New Pressure Dosed Trench Septic System to Serve  
Proposed 1 BR House, Public Restrooms & Horse Wash

**PROPOSED SANITARY SEWER SYSTEM MAP**  
**BEAR CREEK STABLES**  
(APN: 544-32-001)

October 26, 2017

PROJECT NUMBER: **SR0854209**  
PROJECT NAME: **BEAR CREEK STABLES**  
PROJECT ADDRESS: **19100 BEAR CREEK RD.**  
PROJECT CITY: **LOS GATOS**  
ASSESSORS PARCEL NO.: **544-32-001**

OWTS 1

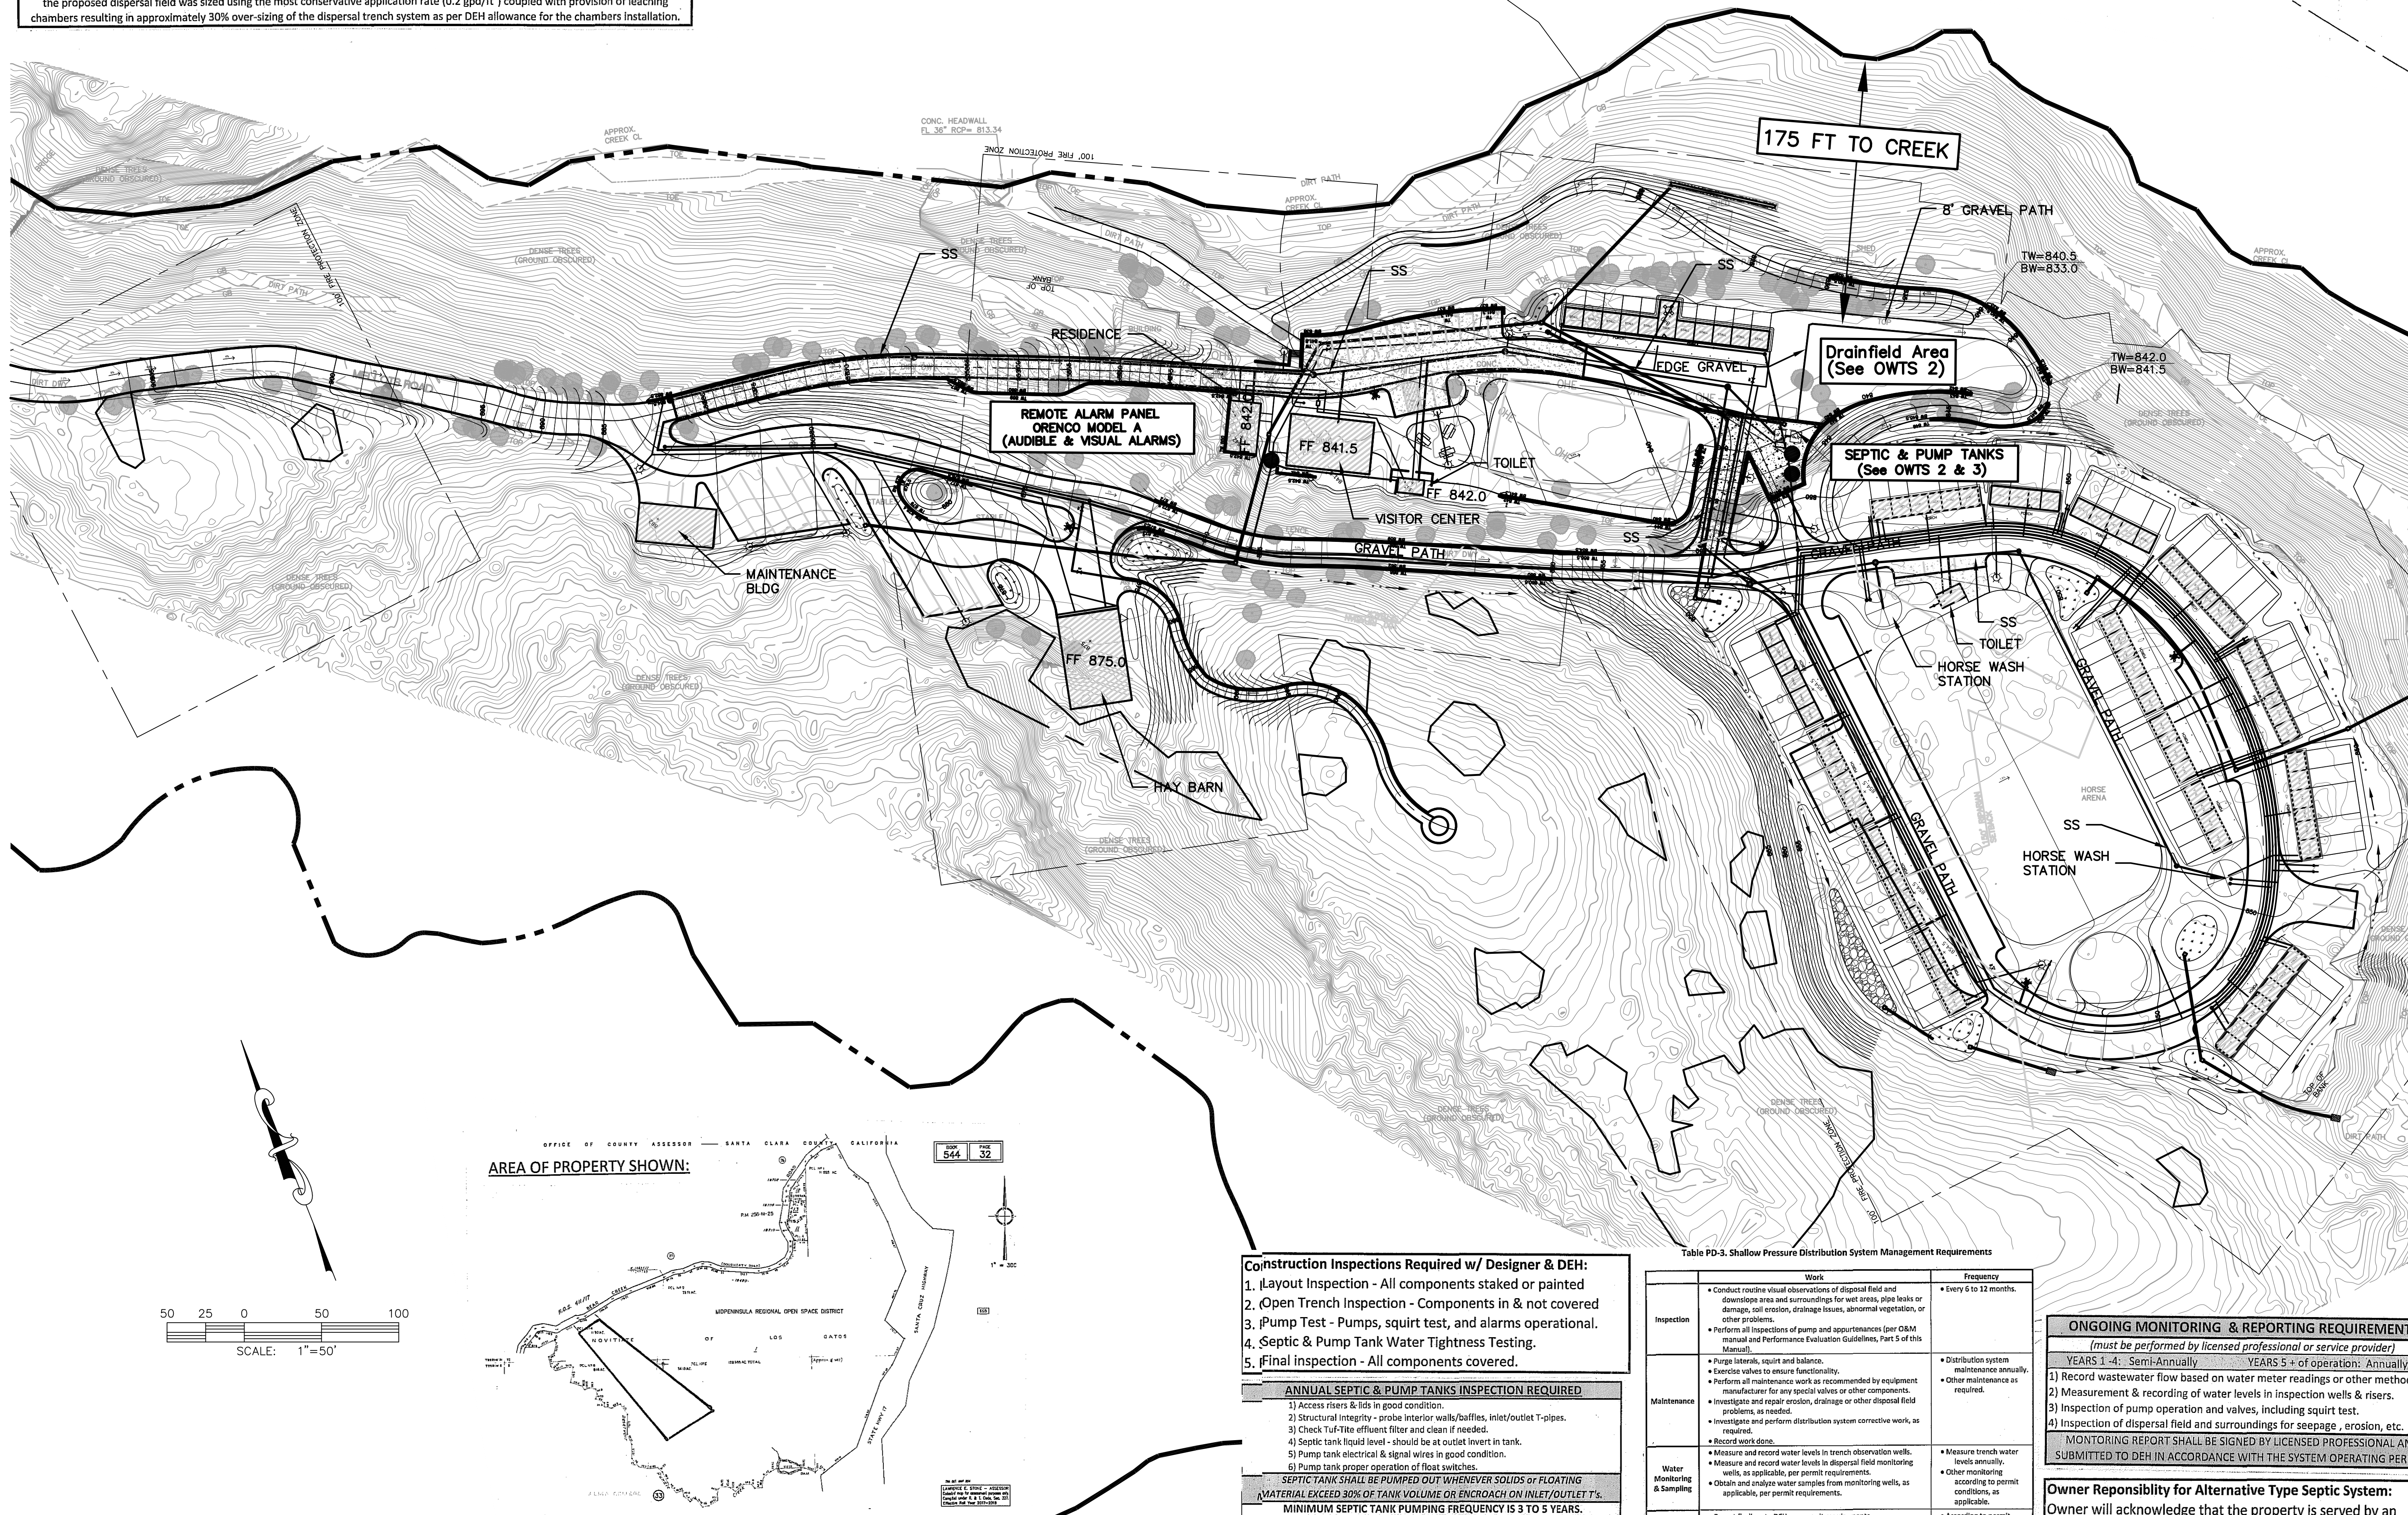
2. The OWTS plans need to be modified as follows:
  - a. Narrative on OWTS 1 implies that the system is being oversized by 30% due to not utilizing the chamber reduction allowance, however, the current design proposal is sized with a 5 sqft/linear foot credit. The Shallow Pressure Distribution guidelines do not allow for greater than 4 sqft/linear foot credit. Ensure that the proposal is revised accordingly.

- b. Soil profile locations do not match inspection notes in DEH files. Ensure that soil profile locations are revised to accurately depict the areas evaluated. Include area of fill encountered, with notation for installation around fill as necessary.

- c. Ensure that additional evaluation by a hydrogeologist is conducted, with report provided to support the determination that the previously designated seasonal drainage was not originally a natural feature. Otherwise, ensure that a 50' minimum setback to seasonal drainage way is maintained.

- d. Ensure that minimum 10' setback is maintained from all potable water utility lines and storage tanks. Include notation for required double-sleeving for all septic tightlines located with 10' of an existing water line.

- g. Specify spacing between drainfields in Zone A and Zone B (minimum 6').
  - h. Provide notation indicating required use of 150 psi pressure-rated PVC piping for all pipes, fittings and valves. Include requirement that all joints must be solvent welded.
